**Title:** Parts 1 and 4 Inspection Planning Methodology modifications

**Purpose:** Second ballot of Parts and 4 detailing the step by step calculations for inspection planning.

**Primary Sponsor:** *Name:* Lynne Kaley  
*Company:* Trinity Bridge, LLC  
*Phone:* 713-458-0098  
*E-mail:* [lynnek@trinity-bridge.com](mailto:lynnek@trinity-bridge.com)

Figure 4.1—Case 1: Inspection Planning when the Risk Target Is Exceeded During the Plan Period

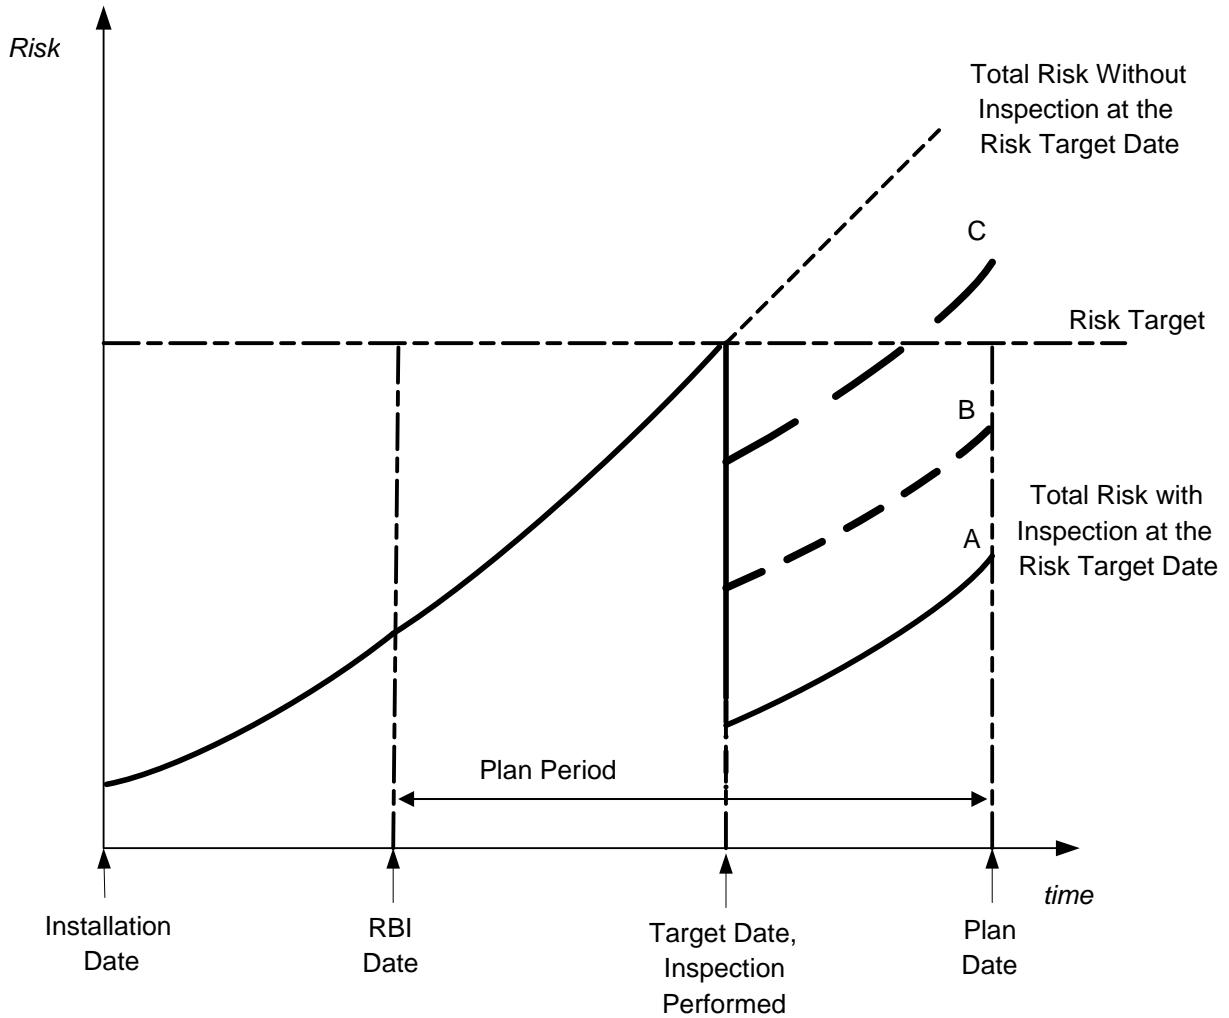
- a) Case 1—Risk Target Is Exceeded During the Plan Period—As shown in Figure 4.1, the inspection plan will be based on the inspection effectiveness required to reduce the risk and maintain it below the risk target through the plan period.
- b) Case 2—Risk Exceeds the Risk Target at the Time the RBI Date—As shown in Figure 4.2, the risk at the start time of the RBI analysis, or RBI date, exceeds the risk target. An inspection is recommended as soon as practical. The plan should be sufficient to reduce the risk so that the risk after inspection

The concept of how the different inspection techniques with different effectiveness levels can reduce risk is shown in Figure 4.1. In the example shown, a minimum of a *B Level* inspection was recommended at the target date. This inspection level was sufficient since the risk predicted after the inspection was performed was determined to be below the risk target at the plan date. Note that in Figure 4.1, a *C Level* inspection at the target date would not have been sufficient to satisfy the risk target criteria.

**Figure 4.3—Case 3: Inspection Planning when Risk Target Is Not Exceeded During the Plan Period**

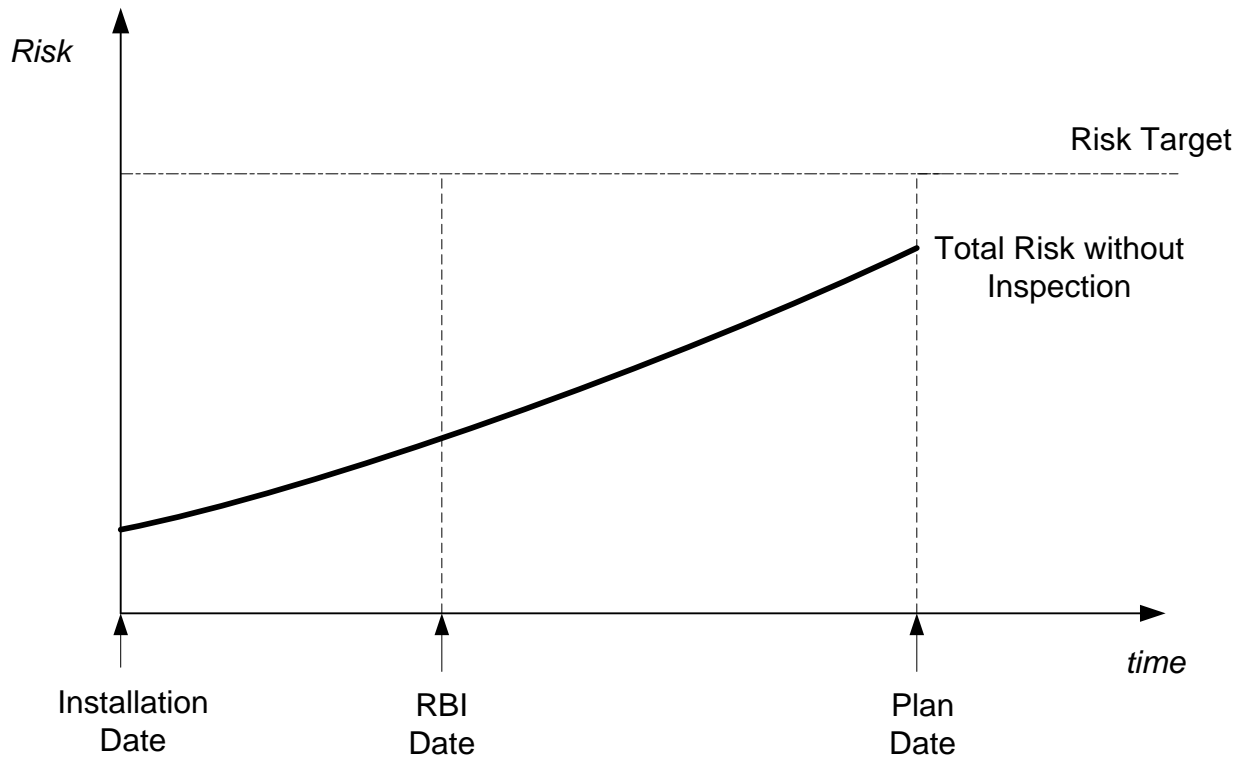
- c) Case 3—Risk at the Plan Date Does Not Exceed the Risk Target—As shown in Figure 4.3, the risk at the plan date does not exceed the risk target and therefore no inspection is required during the plan period. In this case, the inspection due date for inspection scheduling purposes may be set to the plan date so that reanalysis of risk will be performed by the end of the plan period.
